Addendum #2

Project: Hamilton-Wentworth District School Board
REFERENCE NO. 2025-137-P02085
Franklin Road Music Corridors and Washroom Renovation

Addendum No. 1

Project: HWDSB-P02085 – Franklin Road ES Renovation

SK-01 AD-01

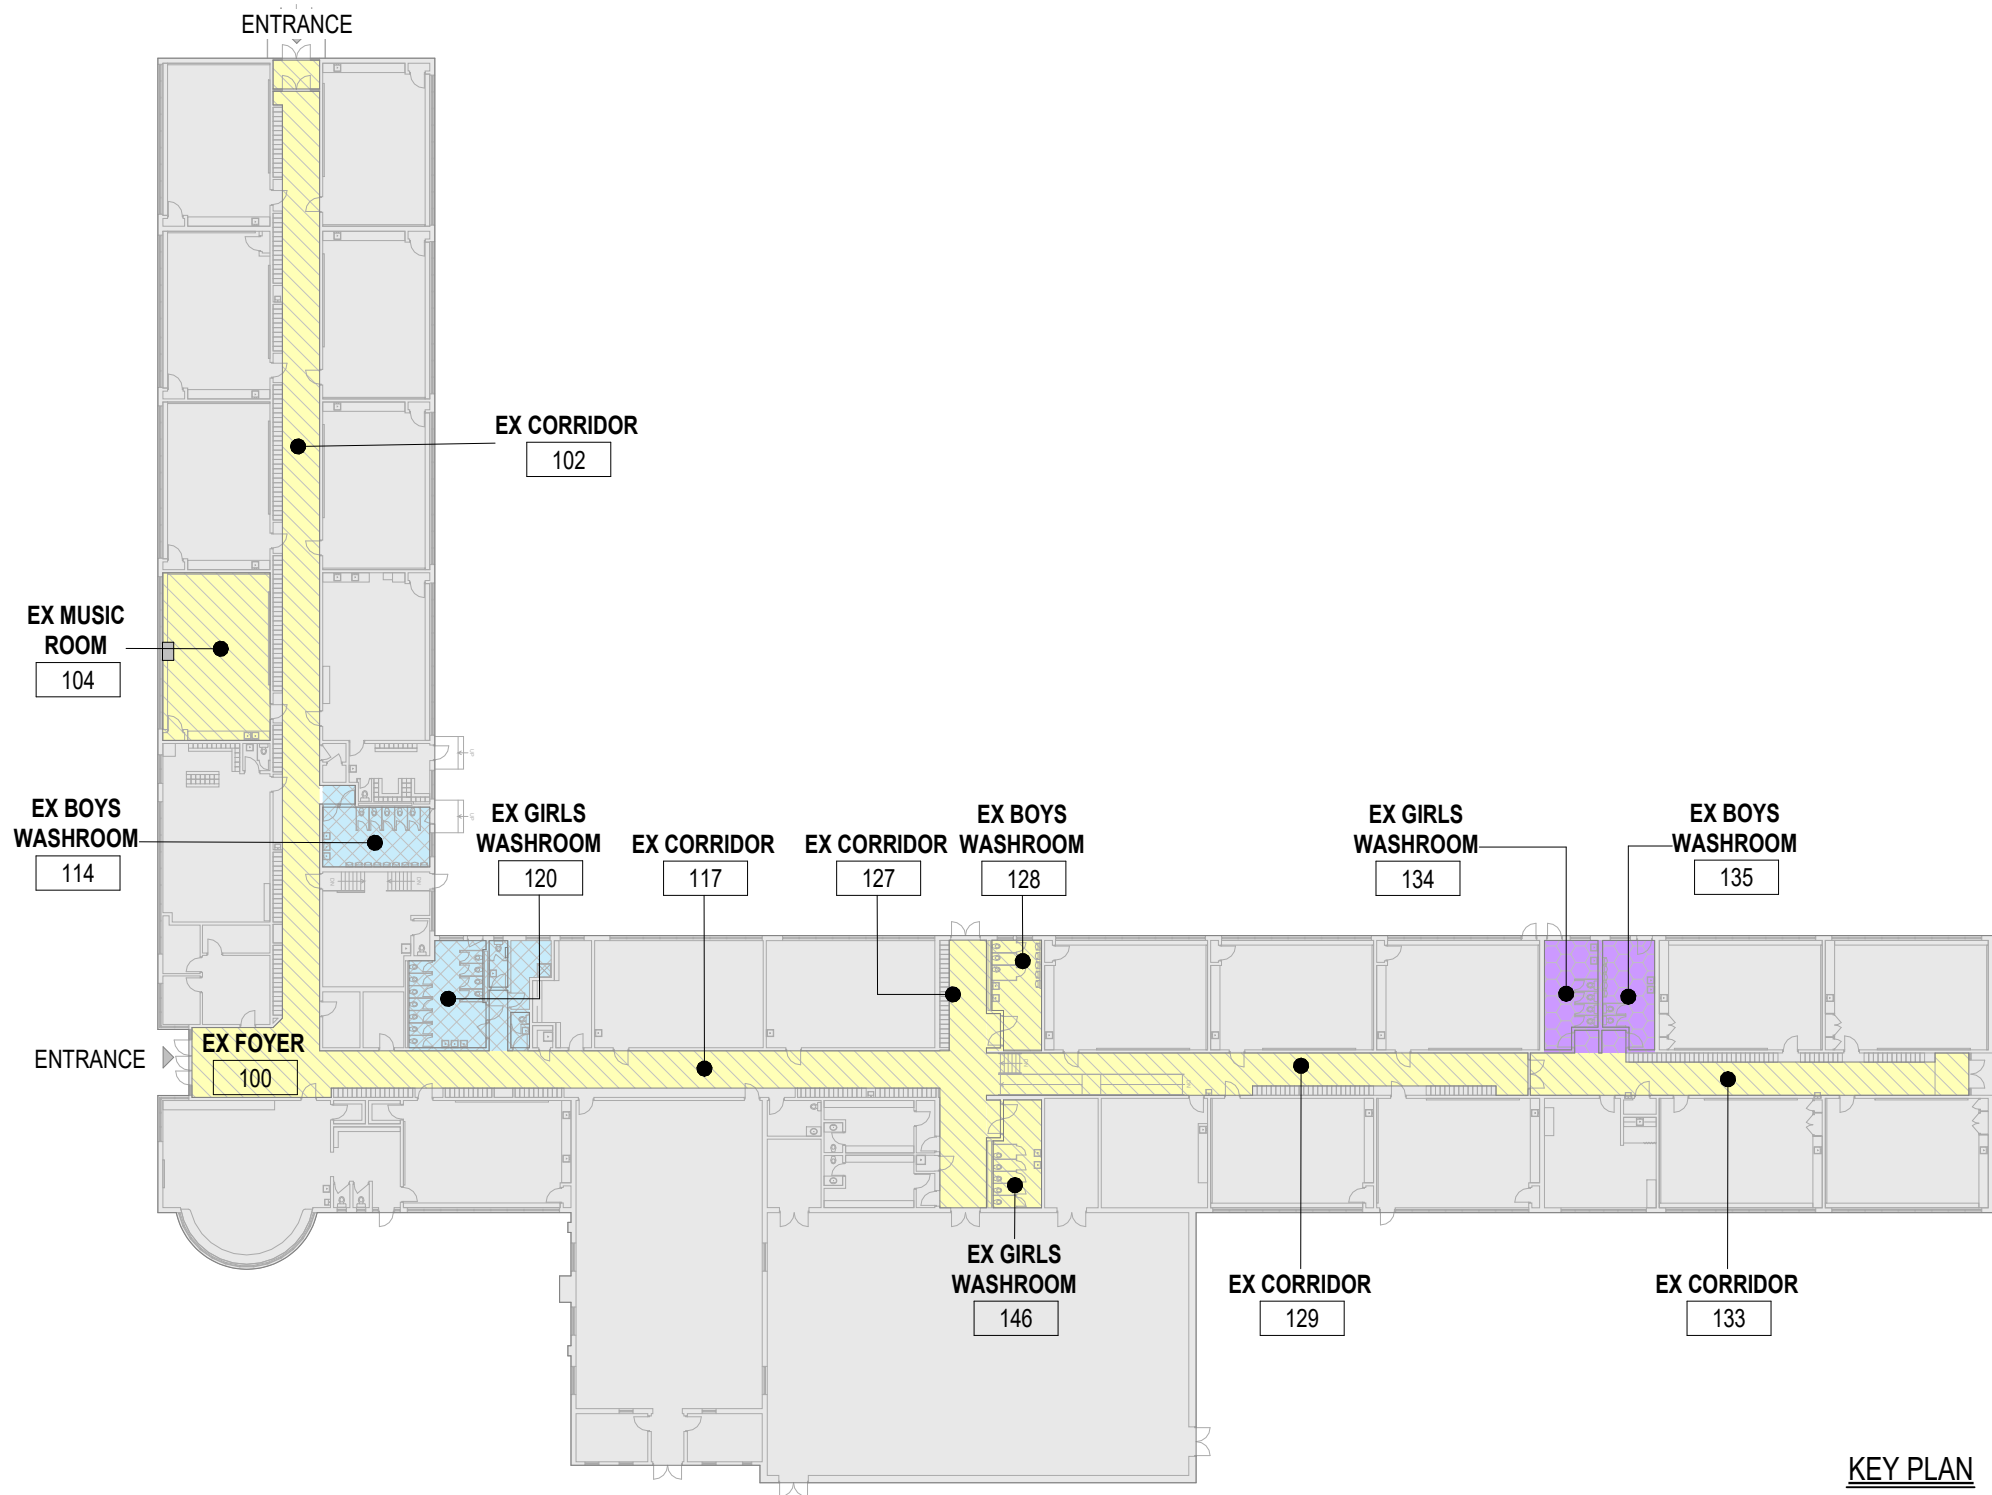
- 3.1. Drawing A0.01, Furring Wall Schedule – F2:
Replace 38 mm furring channels with 64 mm steel studs
- 3.2. Drawing A2.00 – Room Finish Schedule
ADD Note: Ceramic tiles wall finish to be 1,800 mm high.
- 3.3. Drawings A2.01, A2.03, A2.04, A2.05 – Floor Plans
Refer to the **attached** Sketch SK AD-01 for the General Tile Pattern Layout.
Applicable to all washrooms with tile floor finish.
- 3.4. Drawings A2.01 – DOOR SCHEDULE
Door # D123: Add: Modify existing door as required for new floor tile finish

drawing title:
MECHANICAL SYSTEMS -
NEW OVERALL PLAN.

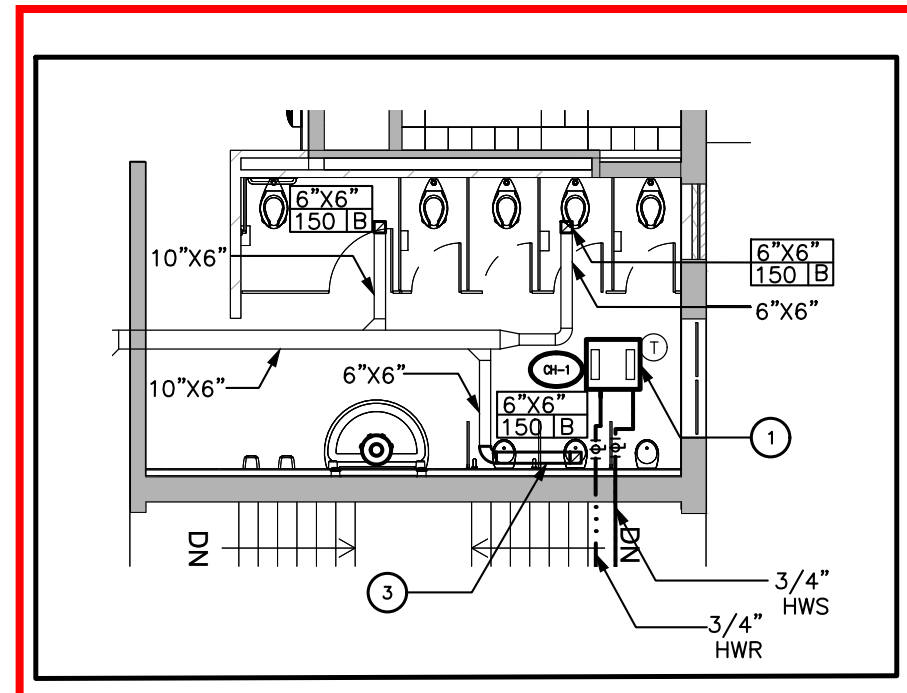
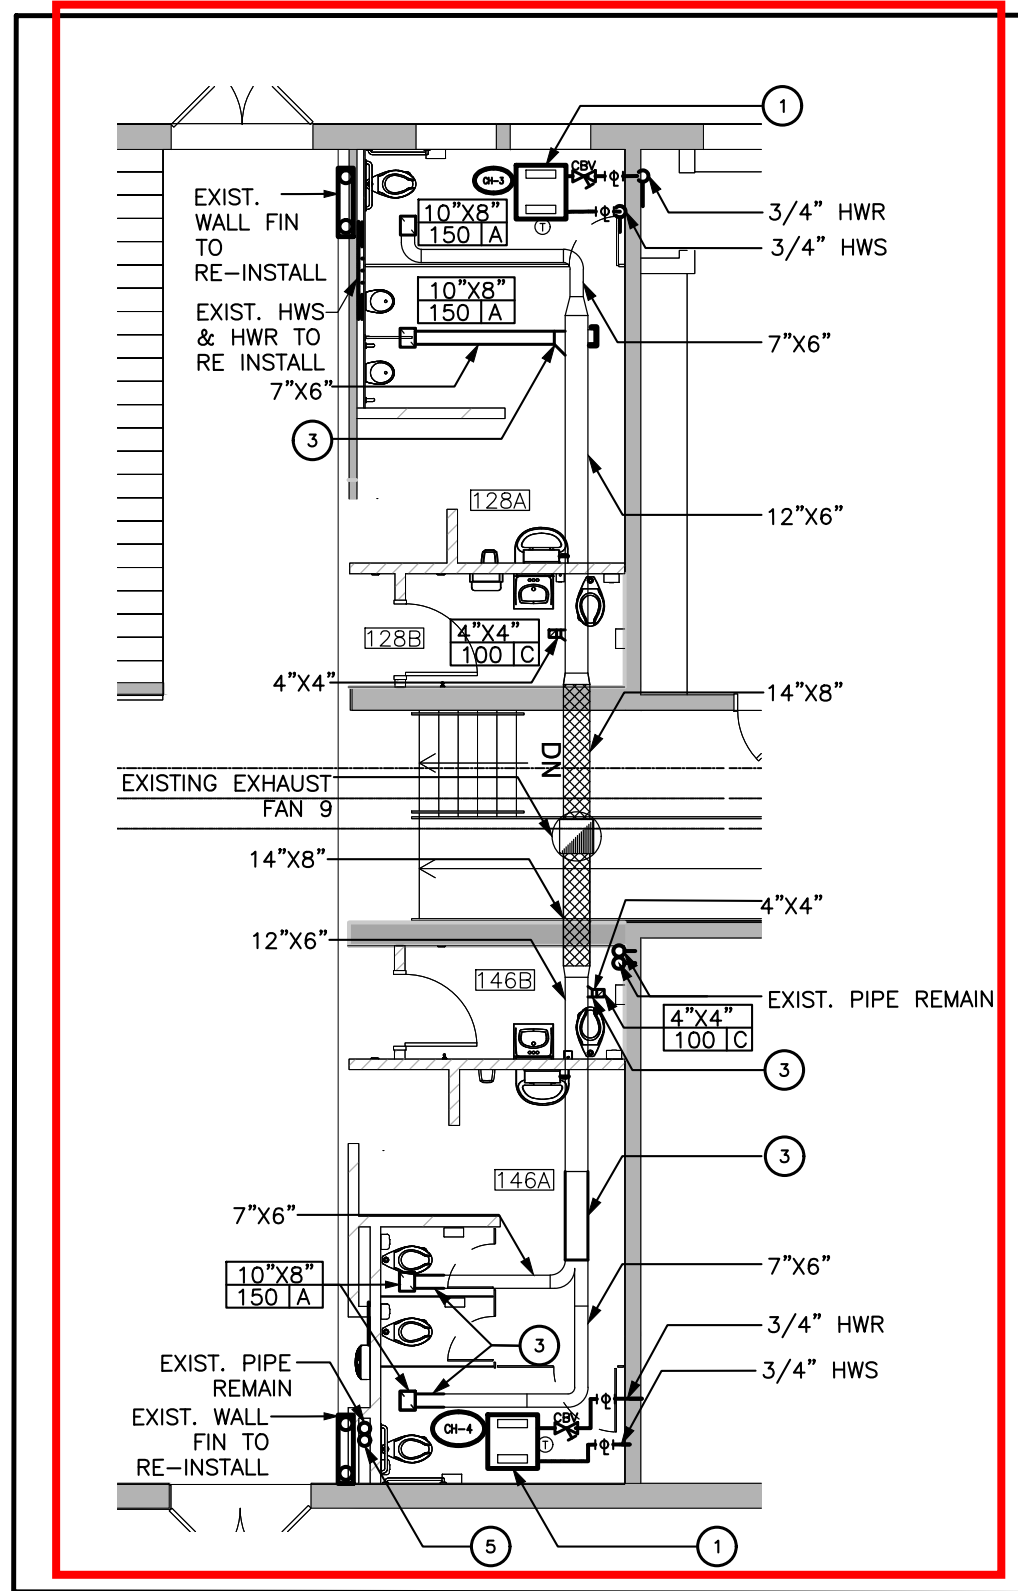
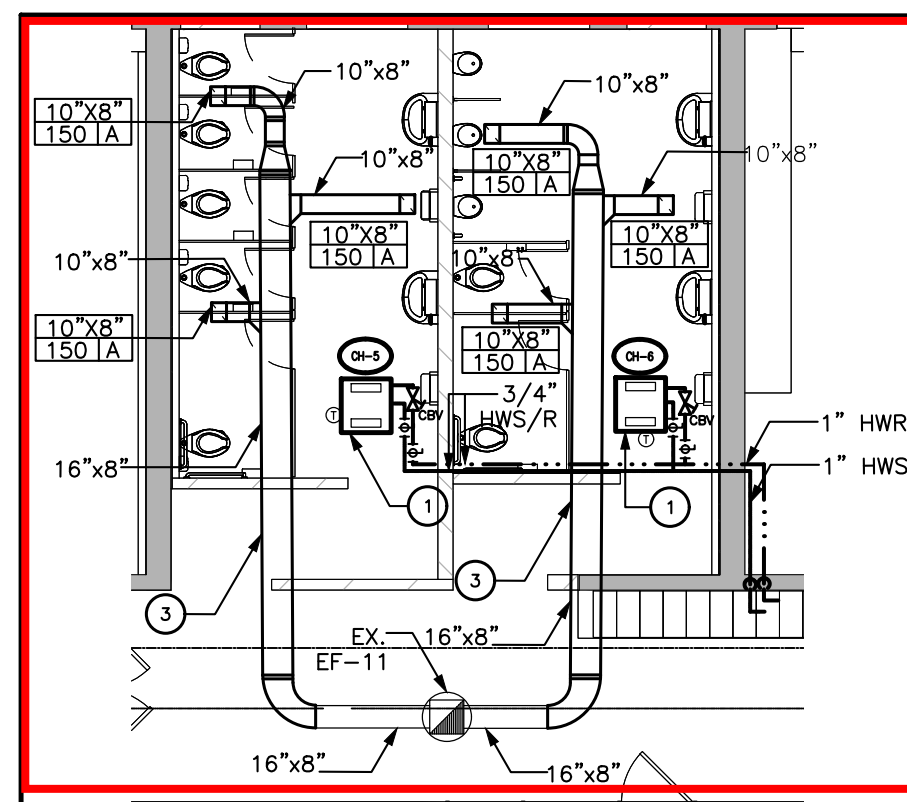
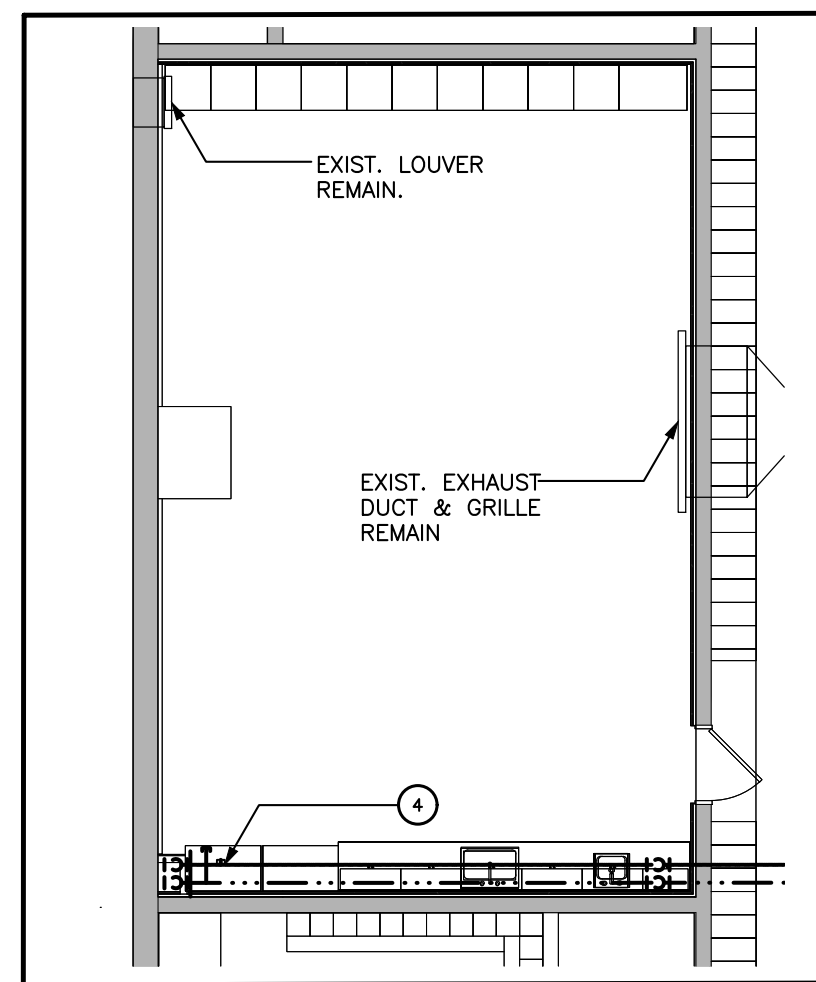
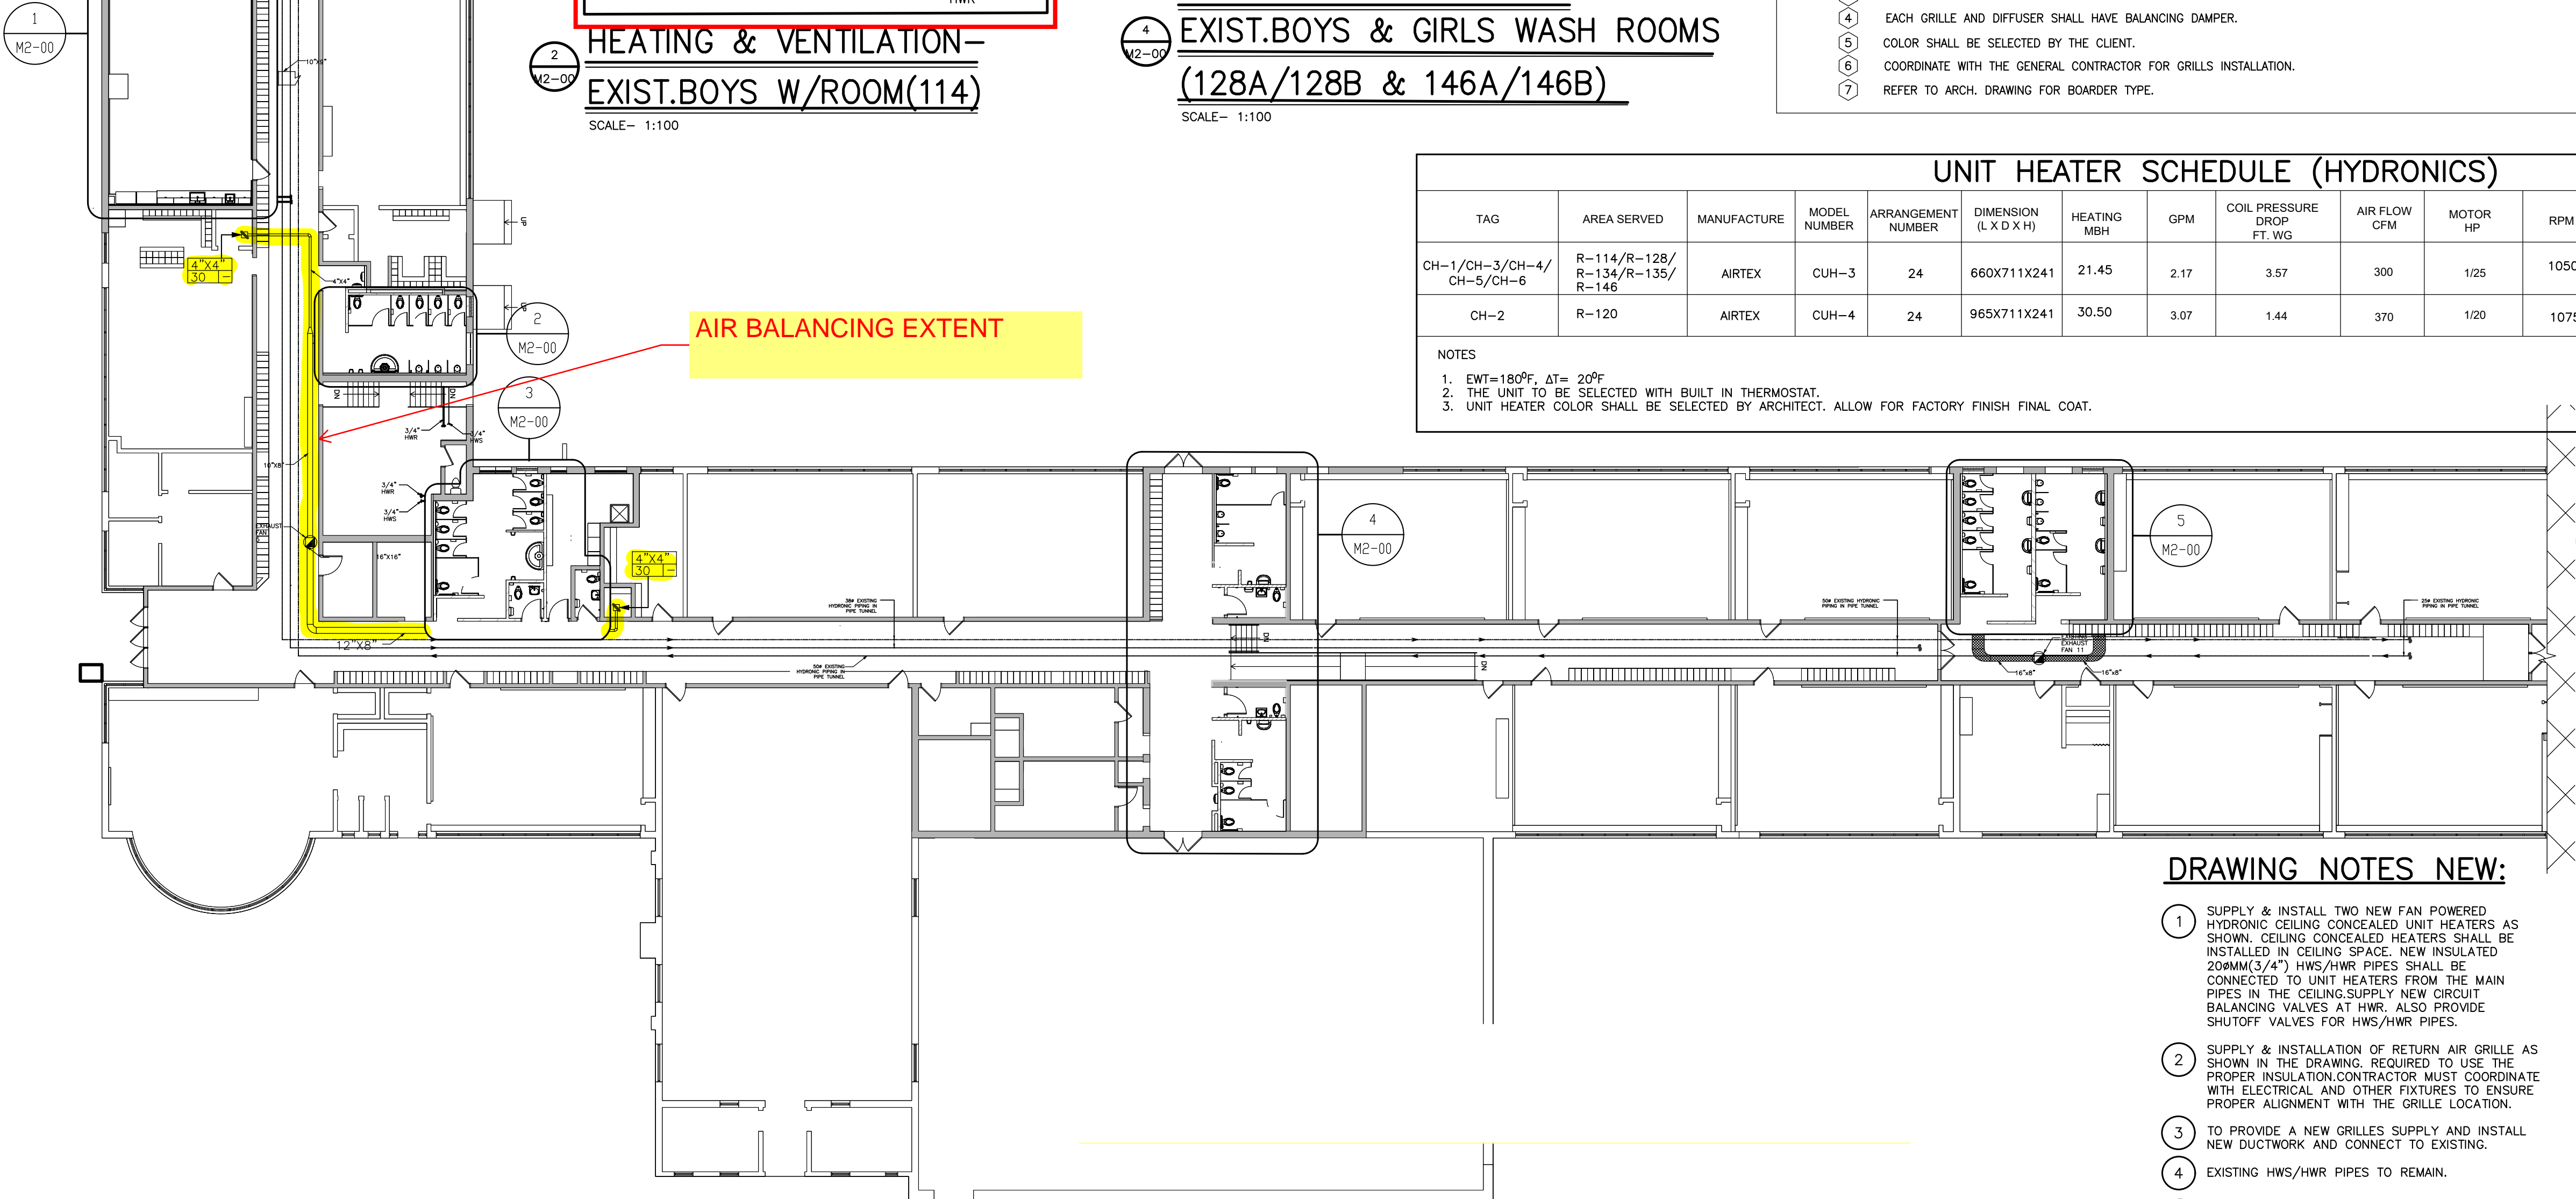
AIR AND WATER BALANCING REQUIRED IN ALL THESE HIGHLIGHTED WASHROOMS
